Construction of a Sales Centre (two storey) comprising Showroom, Office and Café with associated car park and signage

Calton Road, Gawler East, Lot 9010 CT 6205/146 (Proposed lot 1006 in DA 490/D025/19)

DA 490/E005/19

ASSESSMENT REPORT

Visual Representation of Recommendations as per above comments.

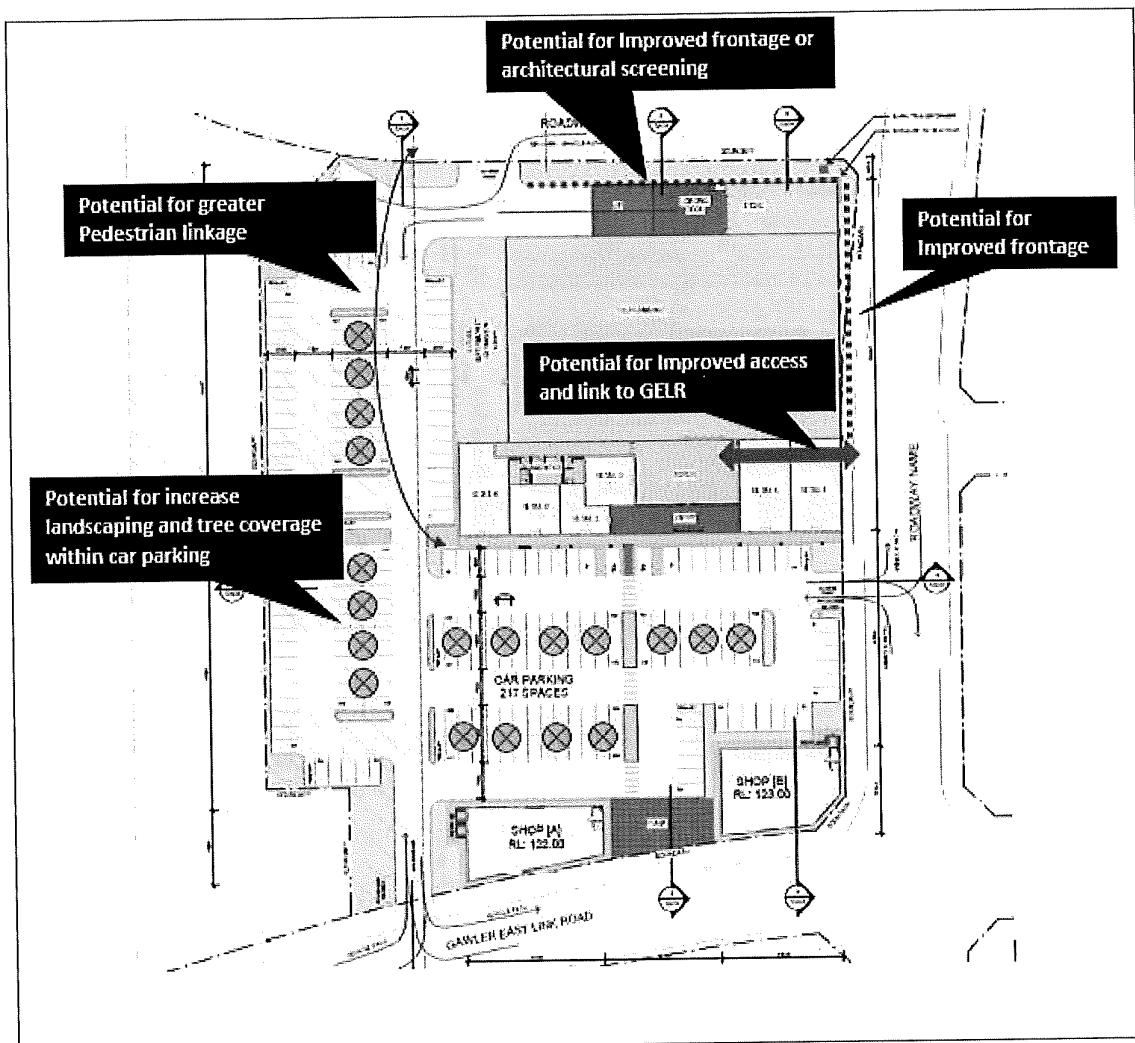
<p>the 8 metre pylon sign height would be encouraged to satisfy this provision.</p> <p>3. Consideration should also be given to whether the proposed pylon signs will maintain appropriate driver sight lines as a result of their close association with vehicle access/egress points.</p> <p>4. Signage contained within the proposal aligns with Table Ga/4 of the Town of Gawler Development Plan and does not offend CW Objectives 69, 70 nor PDC's 199, 200, 201, 202 and 204.</p>
General Infrastructure Provision	<p>1. Zone PDC 42 outlines that development should only occur if the required physical and community infrastructure has been provided or secured via a legally binding agreement.</p> <p>2. The physical and community infrastructure outlined within this provision includes:</p> <ul style="list-style-type: none"> <i>a. Gawler East Link Road as illustrated on Structure Plan Map Ga/1 (Overlay 1) Enlargement G, and associated traffic interventions (road and intersection upgrades);</i> <i>b. public lighting, pedestrian and bicycle paths and associated landscaping treatments associated with the Gawler East Link Road;</i> <i>c. community facilities (including recreation facilities); and</i> <i>d. stormwater management systems.</i> <p>3. To date this infrastructure has not been completed/provided nor secured. As such, the proposal does not satisfy Zone PDC 42 (being all elements a to d as above).</p>

<p>SEAGas and ElectraNet informal referral</p>	<p>1. Whilst the proposed application does not trigger any referrals under Schedule 8 of the <i>Development Regulation 2008</i>, it is highly recommended that following informal referrals are sought to ensure public safety and compliance by the following utility providers:</p> <p>1.1 SEAGas to ensure compliance with AS2885 and Zone PDC 36 (b) given that the proposed shopping centre will contain high concentrations of people within close proximity to the SEA Gas high pressure pipeline.</p> <p>1.2 ElectraNet given that the proposed Shopping centre is encroaching within the transmission line corridor and in particular is currently at variance with Zone PDC 19(c) which seeks a 100metre wide corridor within the existing ElectraNet easement and transmission corridor.</p>
---	---

Visual Representation of Recommendations

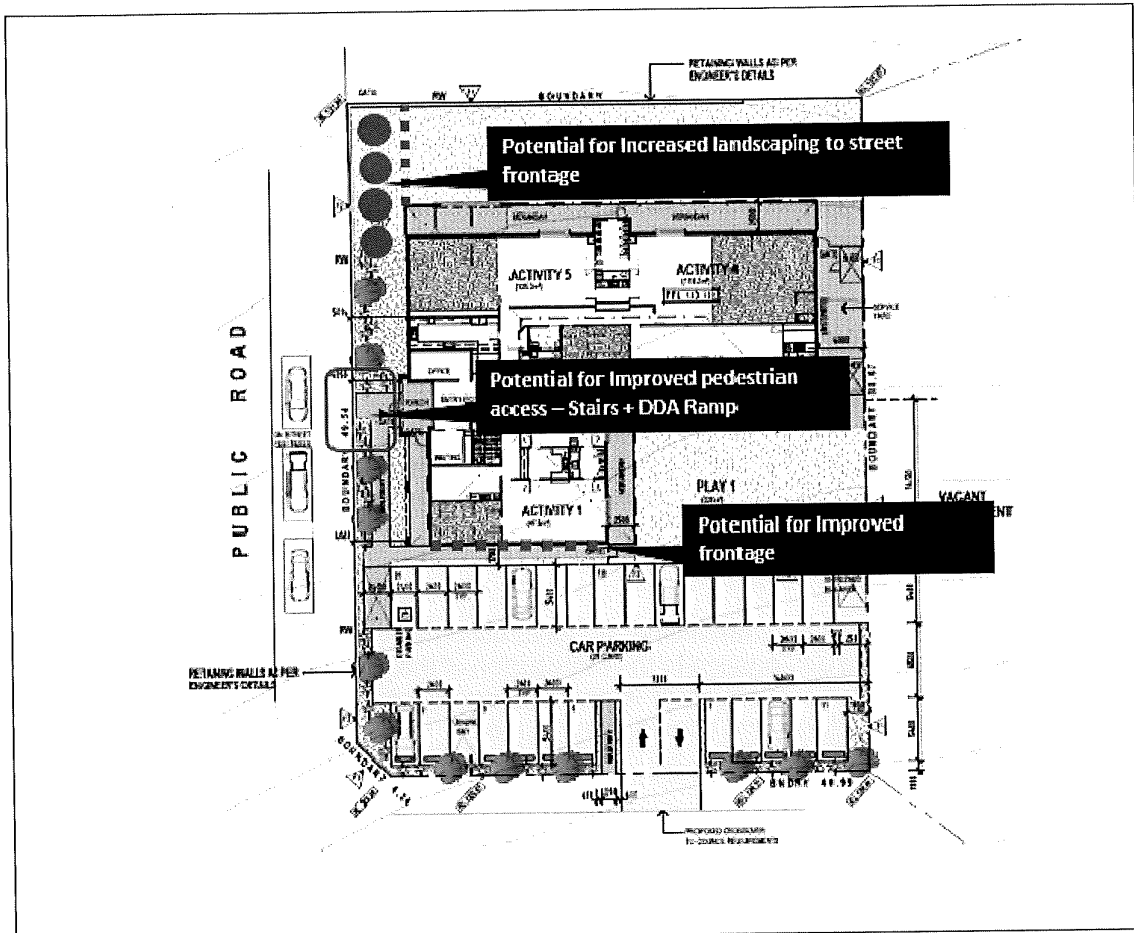
General Infrastructure Provision	<ol style="list-style-type: none"> 1. Zone PDC 42 outlines that development should only occur if the required physical and community infrastructure has been provided or secured via a legally binding agreement. 2. The physical and community infrastructure outlined within this provision includes:

<p>a) <i>Gawler East Link Road as illustrated on Structure Plan Map Ga/1 (Overlay 1) Enlargement G, and associated traffic interventions (road and intersection upgrades);</i></p> <p>b) <i>public lighting, pedestrian and bicycle paths and associated landscaping treatments associated with the Gawler East Link Road;</i></p> <p>c) <i>community facilities (including recreation facilities); and</i></p> <p>d) <i>stormwater management systems.</i></p> <p>3. To date this infrastructure has not been completed/provided nor secured. As such, the proposal does not satisfy Zone PDC 42 (being all elements a to d):</p>
SEAGas informal referral	<p>1. Whilst the proposed application does not trigger any referrals under Schedule 8 of the <i>Development Regulation 2008</i>, it is highly recommended that informal referral is sought by SEA Gas to ensure compliance with AS2885 and Zone PDC 36 (b) given that the proposed childcare centre will contain high concentrations of people including children within close proximity to the SEA Gas high pressure pipeline.</p>

Visual Representation of Recommendations as per above comments.

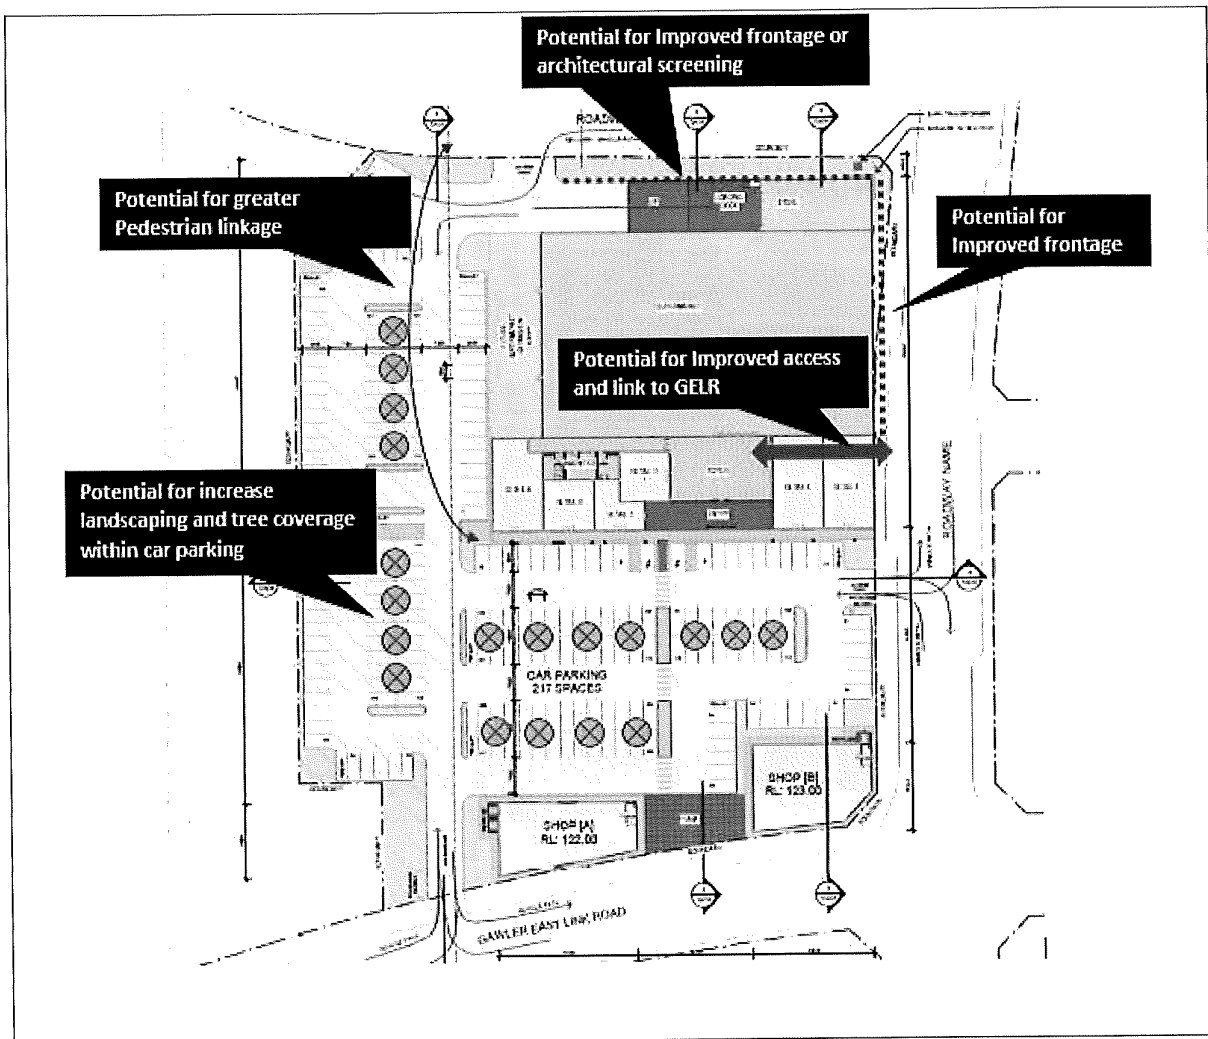
<p><i>b) public lighting, pedestrian and bicycle paths and associated landscaping treatments associated with the Gawler East Link Road;</i></p> <p><i>c) community facilities (including recreation facilities); and</i></p> <p><i>d) stormwater management systems.</i></p> <p>1. To date this infrastructure has not been completed/provided nor secured. As such, the proposal does not satisfy Zone PDC 42 (being all elements a to d).</p>
SEAGas and ElectraNet informal referral	<p>1. Whilst the proposed application does not trigger any referrals under Schedule 8 of the <i>Development Regulation 2008</i>, it is highly recommended that following informal referrals are sought to ensure public safety and compliance by the following utility providers:</p> <p>1.2 SEAGas to ensure compliance with AS2885 and Zone PDC 36 (b) given that the proposed shopping centre will contain high concentrations of people within close proximity to the SEA Gas high pressure pipeline.</p> <p>1.3 ElectraNet given that the proposed Shopping centre is encroaching within the transmission line corridor and in particular is currently at variance with Zone PDC 19(c) which seeks a 100metre wide corridor within the existing ElectraNet easement and transmission corridor.</p>

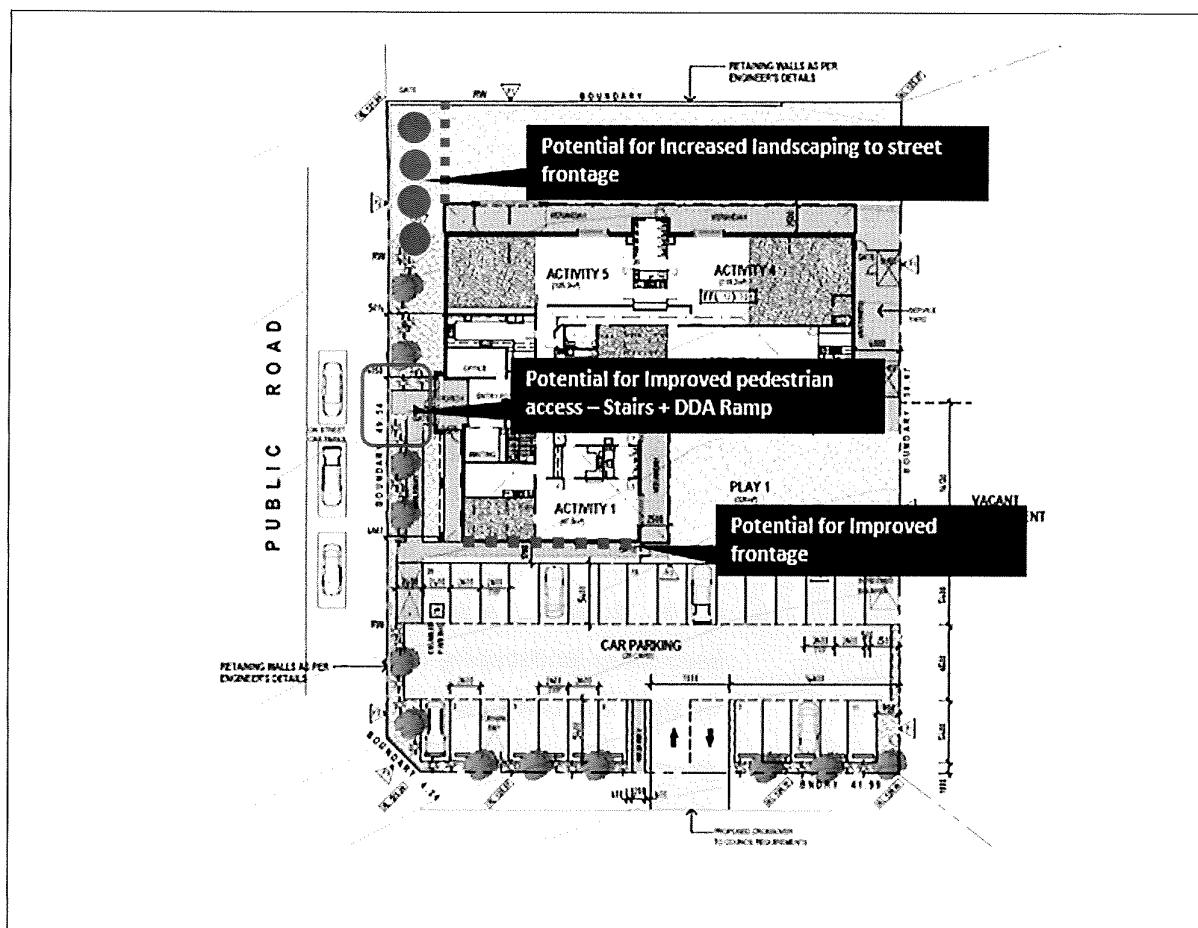
<p>alternative barrier to that of colourbond construction. An acoustic barrier of increased architectural standard would be encouraged given its location within the commercial precinct.</p>
General Infrastructure Provision	<ol style="list-style-type: none"> 1. Zone PDC 42 outlines that development should only occur if the required physical and community infrastructure has been provided or secured via a legally binding agreement. 2. The physical and community infrastructure outlined within this provision includes: <ol style="list-style-type: none"> a) <i>Gawler East Link Road as illustrated on Structure Plan Map Ga/1 (Overlay 1) Enlargement G, and associated traffic interventions (road and intersection upgrades);</i> b) <i>public lighting, pedestrian and bicycle paths and associated landscaping treatments associated with the Gawler East Link Road;</i> c) <i>community facilities (including recreation facilities); and</i> d) <i>stormwater management systems.</i> 3. To date this infrastructure has not been completed/provided nor secured. As such, the proposal does not satisfy Zone PDC 42 (being all elements a to d).

SEAGas informal referral	<ol style="list-style-type: none"> 1. Whilst the proposed application does not trigger any referrals under Schedule 8 of the <i>Development Regulation 2008</i>, it is highly recommended that informal referral is sought by SEA Gas to ensure compliance with AS2885 and Zone PDC 36 (b) given that the proposed childcare centre will contain high concentrations of people including children within close proximity to the SEA Gas high pressure pipeline.
Visual Representation of Recommendations
